BROADCOM

PA- 294946

Product Advisory

PCB Component Footprint change

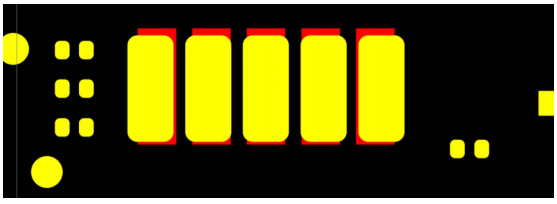
The 9560-16i/8i PCB was modified to increase the pad width for the power manager component.

This part is dual sourced and there are slight differences in each vendor's footprint. One vendor's part is more susceptible to being placed off the PCB pads causing resulting in potential manufacturing yield loss. To prevent this, the width of the pads was increased to accommodate both parts. The following picture shows minor changes in the pad width as shown in yellow. There were no other changes to the board.
